DATE: March 11, 2016
TO: BLUE BIRD OWNERS
SUBJECT: RECALL R15YA
DRIVER'S HEATER SWITCH PANEL INVERTER FAILURE

IMPORTANT SAFETY RECALL NOTICE

Driver's Heater Switch Panel Inverter Failure

Remove six (6) screws from Driver's
Heater Control Panel

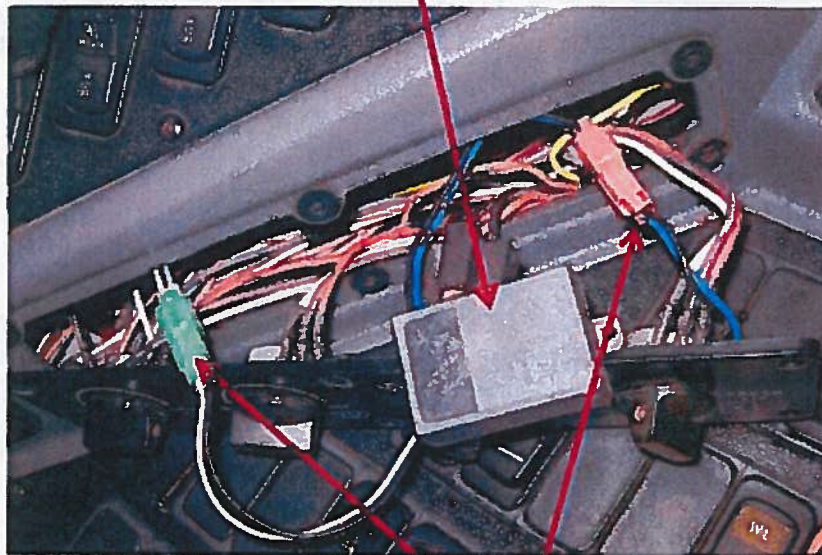
Inverters may have a manufacturing defect where the panel inverter may fail and may produce smoke and a possible thermal event.

1. Park bus, apply parking brake, and remove ignition key.
2. Disconnect battery ground cable(s).
3. Driver's heater control panel is located on the driver's console.
4. Locate and remove six (6) screws that attach panel-to-console.

Replace the inverter with a new inverter.

5. Pull the panel assembly toward the center of the bus to access inverter.
6. Unplug red and green connectors, and then remove inverter.
7. Connect new inverter to the appropriate red and green connectors. Place inverter and wiring back into the driver console and install the six screws that were removed in Step 4.
8. Reconnect battery ground cable(s).
9. Place bus back in service.
